PCN Number : IMS 085

Title / Titre		
Evolution of gearbox		
Affected Products / Produits concernés		
Model designation / Désignation : Brushless Gear Mot. 801896 SMi21 100W Speeds=3500RPM at 24Vdc Ratio=99.52 Stage=3 Vdc=12-48 Reg.Loop=4 Quadrant Program=79298013 Part number / Référence : 80189639		
Application date / Date d'application		
Application will begin in July 2021 and end in December 2022.		
Change type / Nature de la modification		
☐ Raw Material / Matière ☒ Design / Conception ☐ Process / Fabrication ☐ Logistics / Logistique ☐ Quality-Reliability / Qualité-Fiabilité ☐ Others / Autres		
Reason for change / Raison de la modification		
Our supplier changes his design with version PM and stop production of version P.		
Change description / Description de la modification		
Modification of aspect and dimensions.		
Customer impact / Impact client		
Visual appearance / Aspect visuel : See page 2/2 Performance / Performances : Same for P and PM Ordering / Commandes : TBD by supply chain (depend of stock version P) Inventory management / Gestion des stocks : TBD by supply chain (depend of stock version P) Pricing / Prix : TBD by Crouzet sales

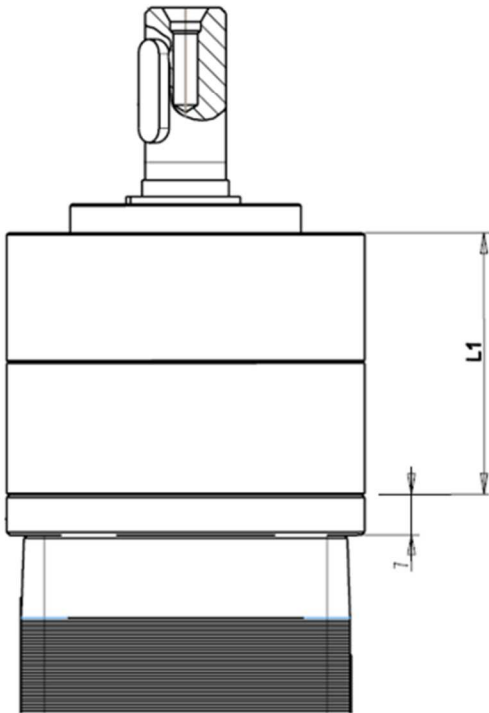
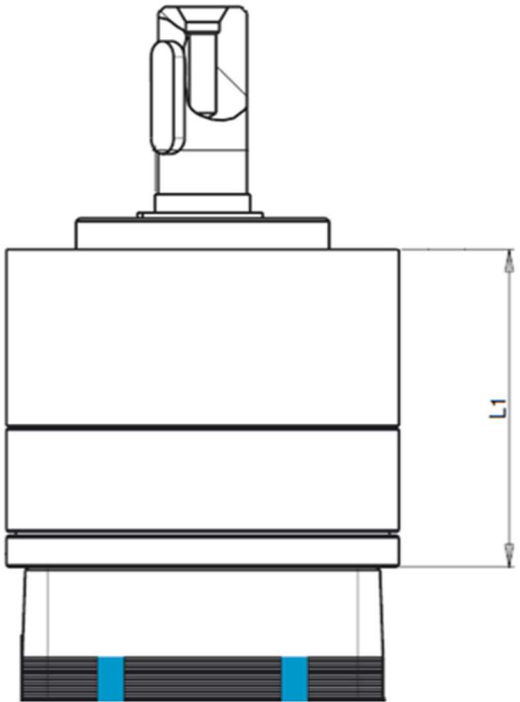
Ref.	801896	
Status	Old	New
Top view	No visual impact	No visual impact
Side View		
Overall Dimension (± 0.6)	(Width Motor Flange + L1)	L1
- 1 Stage	52.1	50.85
- 2 Stage	67.9	67.8
- 3 Stage	83.8	84.7
